11 November 1975

MEMORANDUM FOR THE RECORD.

SUBJECT : Project ORACLE

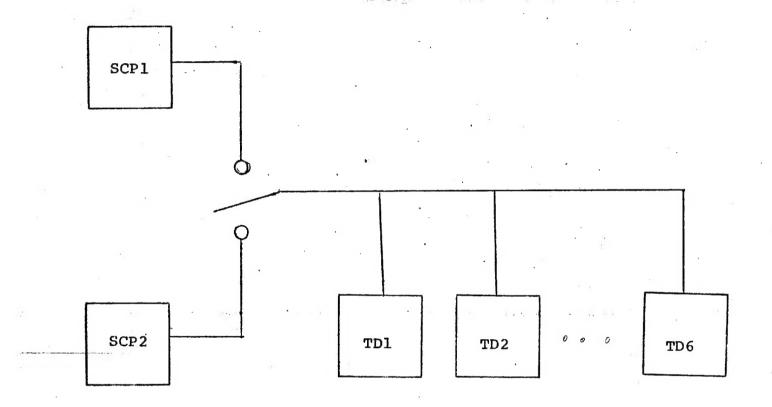
stated that the current design permits one and only one Storage Control Processor (SCP) to be enabled at any given time to access any of the Transport Drivers (TD). The SCP's and TD's are cabled together in such a way that when one SCP is in control of the TD's, the other SCP is blocked from all access to any of the TD's by a hardware interlock. In order for the second SCP to gain access to the TD's, the first SCP must relinquish its control and then it is possible for the second one to take over. Once the second SCP is in control the first one is inhibited from all access to the TD's. Any interrupt issued by a TD is serviced by whichever SCP is currently in control. The TD does not know which SCP should handle the interrupt, it is expected in this design that this type of problem can be adequately solved at the SCP level. The drawing below illustrates how these hardware elements are tied together logically.

The above design gives control, at any given time, of all TD's to a single SCP. If dual SCP control of TD's is desired, the two SCP's could flip-flop by means of software logic. A flip-flop technique would permit segregating or sharing those functions in the two SCP's that require an SCP-TD association. Implementation of such a scheme adds complexity to the software logic which would have to reside in both SCP's. The areas particularly affected are hand-shaking protocols, timing, and recovery. It also requires that a wise choice be made initially as to which functions are shared or segregated between the SCP's. The choice is critical since once designed and implemented, subsequent changes would not be easy.

has chosen not to develop a flip-flop design. They have ruled out any type of dual SCP operation, the second SCP is for back-up only. The hardware design does not permit selective accessing of TD's by both SCP's concurrently and the software design requires that all accesses of TD's be made from only one SCP.

There is a major disadvantage to the design. It is impossible to use the redundant equipment for software development and testing. Although the back-up SCP and TD's can be put off-line there is no way of using them independent of the production system. This means that once the system is in production, fixing of existing bugs can be done only by taking down the production system. Assuming that the production system cannot be down very often such work would require long periods of elapsed time.

- 1. The Storage Control Processors (SCP's) must be able to access the Transport Drivers (TD's) in such a manner that given redundancy of SCP's and TD's, no single failure will cause the entire Mass Storage System to be inoperable.
- 2. A stand-alone SCP must be able to access a TD so that a TBMTAPE can be initialized.
- 3. An SCP must have access to the TD's such that off-line maintenance of an SCP can be concurrent with on-line operation of the Mass Storage System.

Approved For Release 2002/08/15: CIA-RDP83T00573R000500080009-3
FIG. 2.1.11 - EXPANDED DSS CONFIGURATION

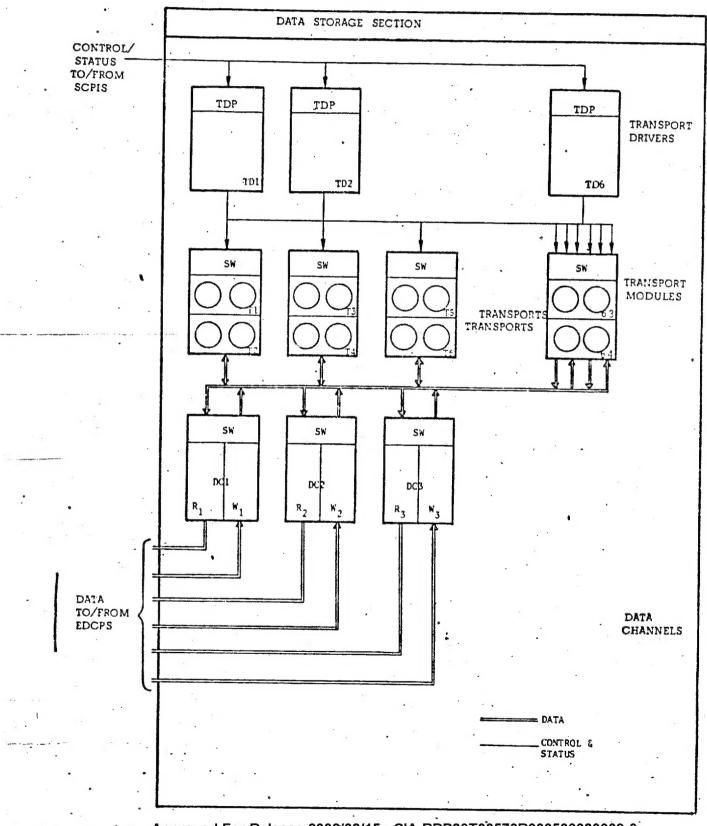
"The hardware modules and the interconnecting switching matrices are described below, and depicted in Figures 2.1.10 and 2.1.11." Inspection of the figure shows that the TD's (up to 6) can access any of up to 64 tape Transports. It also shows the 3 DC's accessing any of the 64 tape Transports. Finally, it shows the 3 DC's servicing 6 EDCP's.

Figure 2.1.11 when related to all the recorded statements by shows:

- Maximums of 6 TD's, 64 Transports, 3 DC's, and 6 EDCP's.
- b. Perfect switching or accessing between related

I feel there is a case to ask _____ to provide perfect STATINTL switching for the maximum system configuration of 6 TD's, 64 Transports, 3 DC's and 6 EDCP's. The weakness in all of the above arguments comes from the lack of positive statements concerning the capabilities of the Data Channels' accessibility. However, in light of the failure of to make specific statements about the limitations of the DC's, it can be argued that it is entirely reasonable to conclude there are no limitations other than those implied by the maximums.
